Access Compliance Report

Public Rights-of-Way

(Pedestrian Signals)

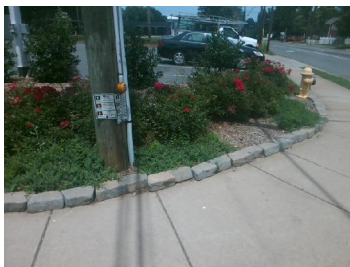
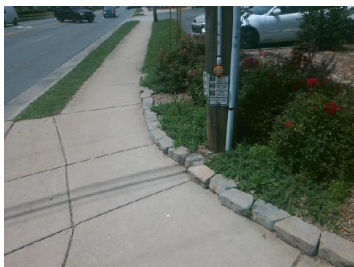
Surveyor Notes: TEXT HT 7/16

PROW/ADA: R410.6, R209.1, TMUTCD 4e.08, R406.2, R404.7.3

Yes	B 1 Clear Xing Direction?	ClearlyMarked	N/A	B 2 Clear Xing Direction?	N/A
	B 1 Crossing Direction	To SE		B 2 Crossing Direction	N/A
Yes	B 1 DistanceTo XWalk (in)	0.0	N/A	B 2 DistanceTo XWalk (in)	N/A
No	B 1 DistanceTo Curb (in)	104.0	N/A	B 2 DistanceTo Curb (in)	N/A
Yes	B 1 Diameter (in)	2.0	N/A	B 2 Diameter (in)	N/A

Possible Solutions: Replace Signal Push Button With APS Button on New Post. Remove & Replace Sign.
